We would like to thank the reviewer for taking the time to review the presented manuscript and provide their appraisal of the research carried out. We will try to provide a satisfactory reply to all the questions raised in this document. The posed questions are in green and the replies are presented below them.

Major Questions

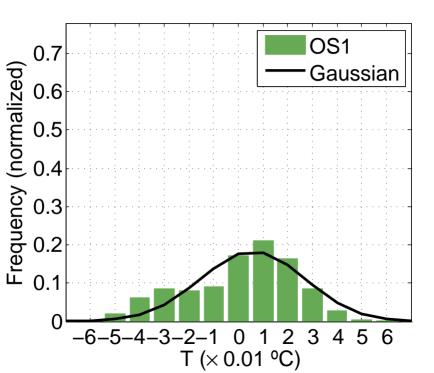
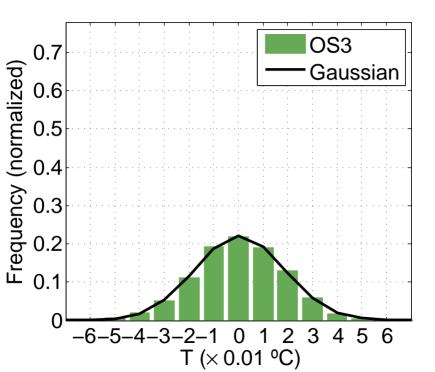
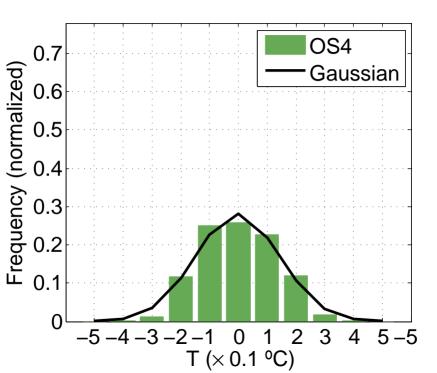
Question 3: Figure 4: How did you choose which sensors you show here? Motivate your choice. You could also show all other sensors in a supplement.

The sensors were chosen as they are the sensors at the middle of each respective string. A supplement has been prepared with the measurements of all other sensors in the string at the respective temperature, containing the requested plots, which are shown at the end of this document. The following text was added to figure 4:

"OS3, TC3 and PT3 were chosen due to being the central sensors of each respective string. The temperatures chosen represent common temperatures used during CLOUD campaigns."
